SUBJECT: FORWARDS PROPOSED AMEND TO OL TECH SEPCS CHANGING SETPOINTS
 OF PRESSURIZER ELECTROMAGNETIC RELIEF VALVE & REACTOR
 COOLANT SYS HIGH PRESSURE TRIP IN RESPONSE TO IE BULLETIN
 79-05B.

Re: Oconee Nuclear Station
Docket Nos. 50-269, -270, -287

Pursuant to 10CFR50, §50.90 and in response to IE Bulletin 79.05B, Item 7, please find attached a proposed amendment to the Oconee Nuclear Station Facility Operating License. This request revises Oconee Nuclear Station Technical Specification 2.2, Safety Limit-Reactor Coolant System Pressure, and Specification 2.3, Limiting Safety System Settings, Protective Instrumentation.

OCONEE NUCLEAR STATION
PROPOSED TECHNICAL SPECIFICATION REVISION

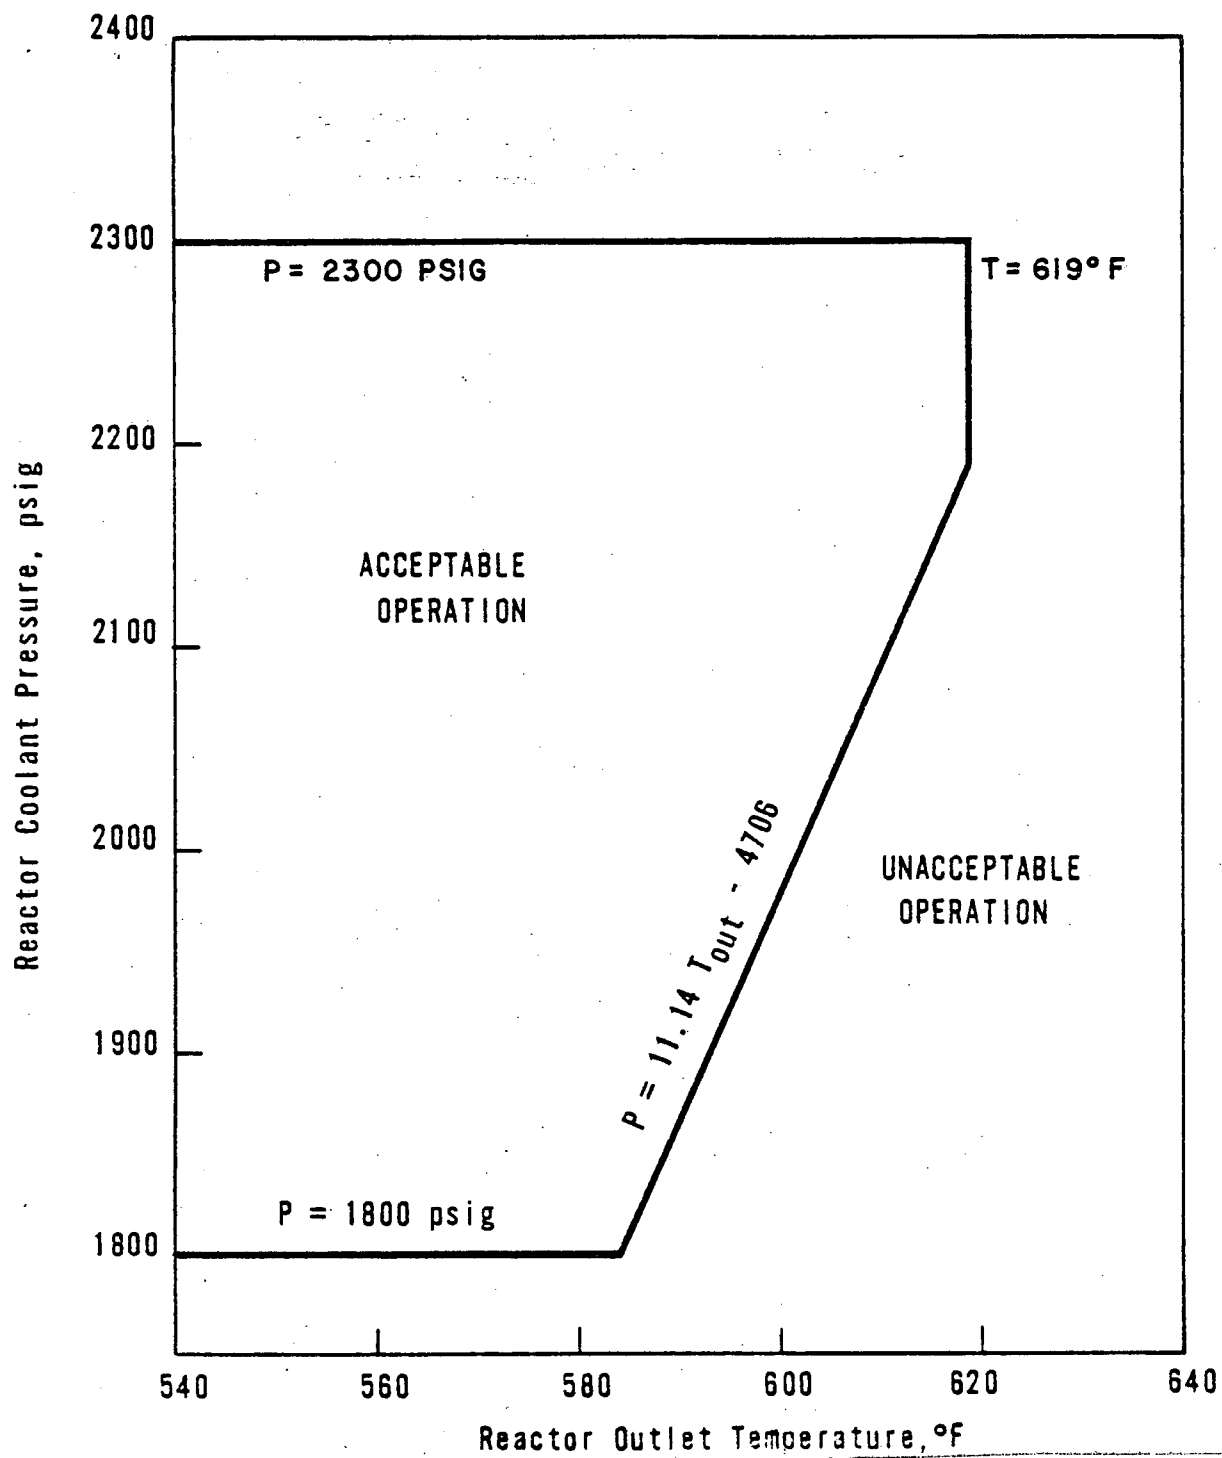
During a startup accident from low power or a slow rod withdrawal from high power, the system high pressure set point is reached before the nuclear over-power trip set point. The trip setting limit shown in Figure 2.3-1A - Unit 1

for high reactor coolant system pressure (2300 psig) has been established to maintain the system pressure below the safety limit (2750 psig) for any design transient. (1)

Figure 2.3-1A

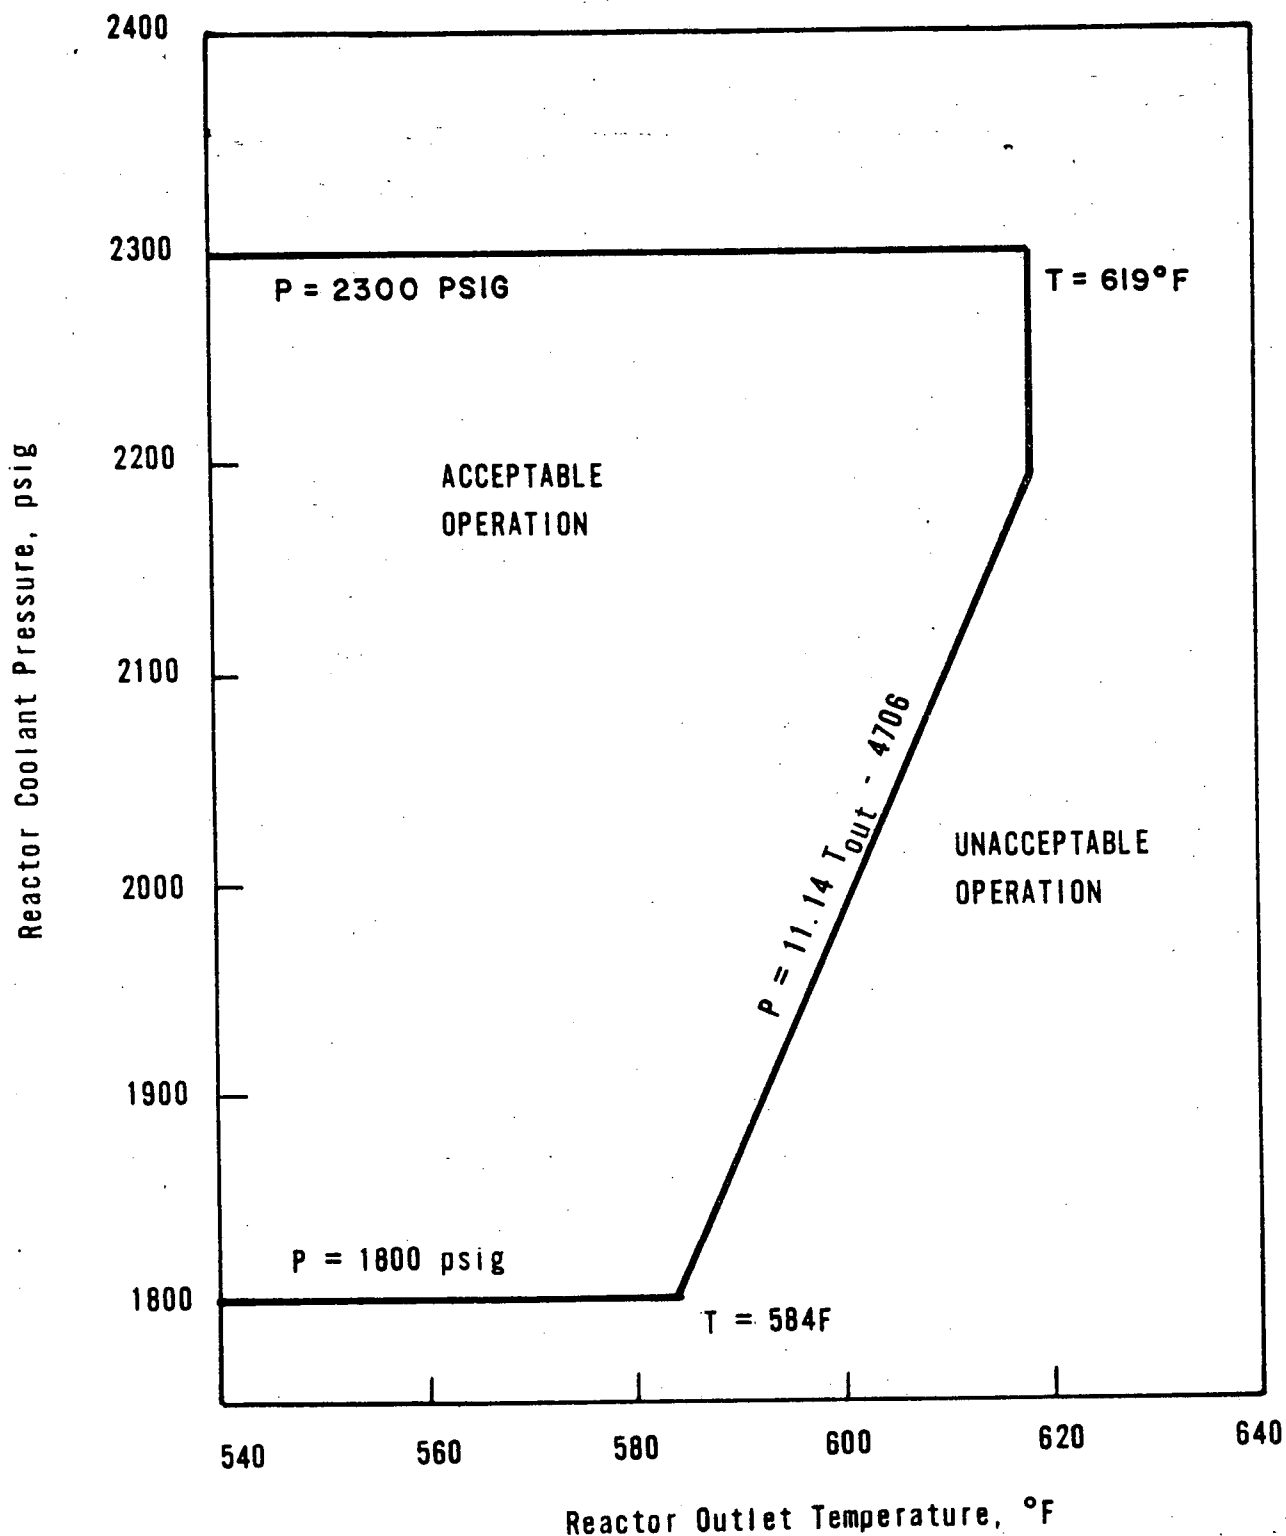
This proposed revision reflects recent changes to the setpoints of the pressurizer electromatic relief valve and the reactor coolant system high pressure trip made in response to IE Bulletin 79-05B.

Figure 2.3-1B

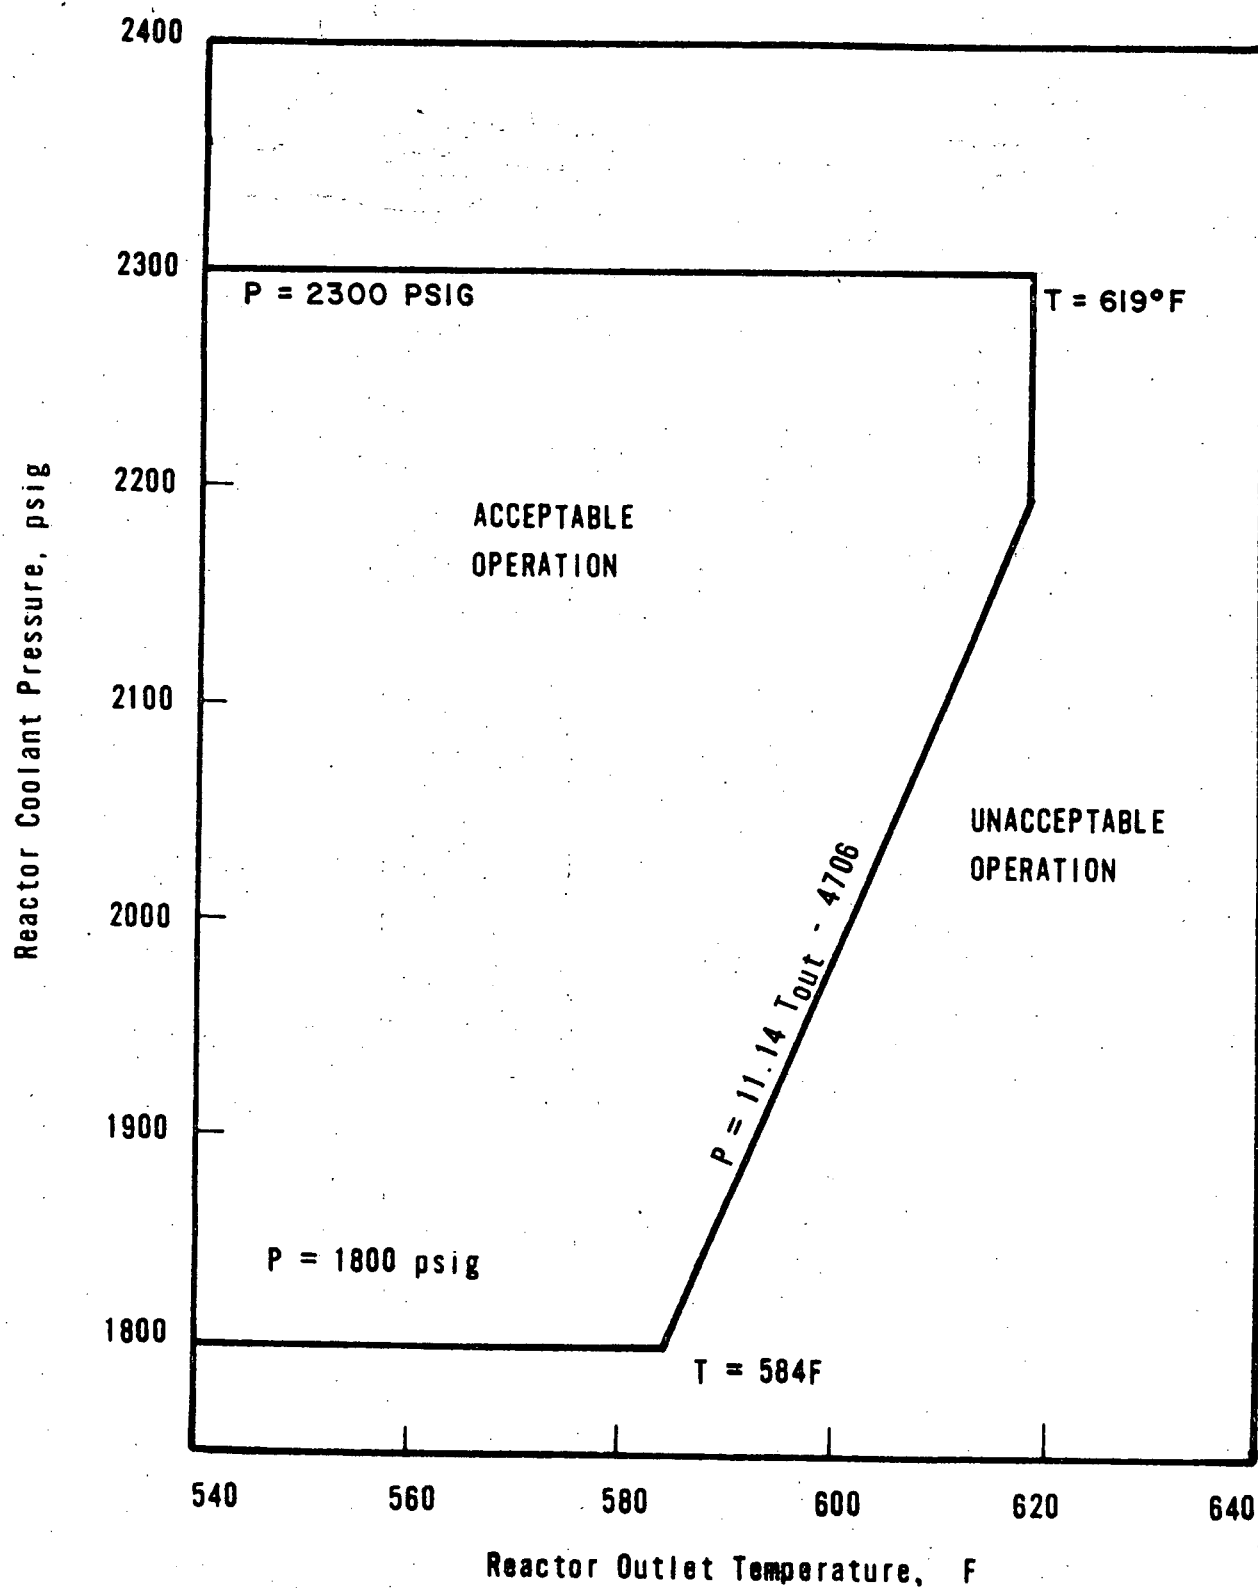
2.3-1B - Unit 2
